CONGRUENT SOFTWARE, INC.
3998 Whittle Avenue
Oakland, CA 94602
(510) 531-5472
(510) 531-5472 FAX

FROM: Peter Johansson
 TO: T10 SBP-2 *ad hoc* Working Group
 DATE: June 4, 1997
 RE: Configuration ROM, power reset and security

The text below reflects agreements reached by the SBP-2 *ad hoc* working group. These changes affect stabilized portions of the SBP-2 draft; consequently they are being held until the July T10 plenary in Colorado Springs, CO, for final approval and inclusion in the subsequent revision of SBP-2.

Figure 56 – Node unique ID leaf format

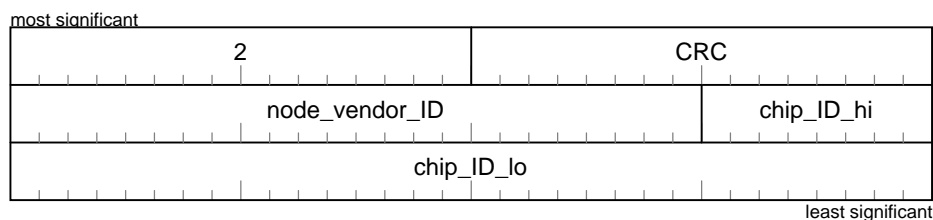
The following clauses are to be deleted. These changes anticipate redefinition of configuration ROM required entries to be addressed by IEEE P1212, the five-year revision of the existing CSR architecture.

7.5 Node unique ID leaf

As specified by ISO/IEC 13213:1994, the node unique ID is a 64-bit number appended to a company ID value to create a globally unique 88-bit number. While conforming to this definition, Serial Bus additionally constrains the 64-bit node unique ID values so that they are unique within the global context of all Serial Bus nodes. Figure 56 shows the format of the node unique ID leaf.

The first quadlet of the node unique leaf shall contain the number of following quadlets in the leaf and a CRC calculated for those quadlets, as specified by ISO/IEC 13213:1994.

The *node_vendor_ID* value shall be the same as the *module_vendor_ID* value from the root directory.

The *chip_ID_hi* field is concatenated with the *chip_ID_lo* field to create a 40-bit chip ID value. The vendor specified by the *node_vendor_ID* value shall administer the chip ID values. When appended to the

~~node_vendor_ID value, these shall form a unique 64-bit value called EUI-64 (Extended Unique Identifier, 64 bits). These EUI-64 values are, by definition, unique from other EUI-64 identifiers derived from the IEEE/RAC-provided company ID value.~~
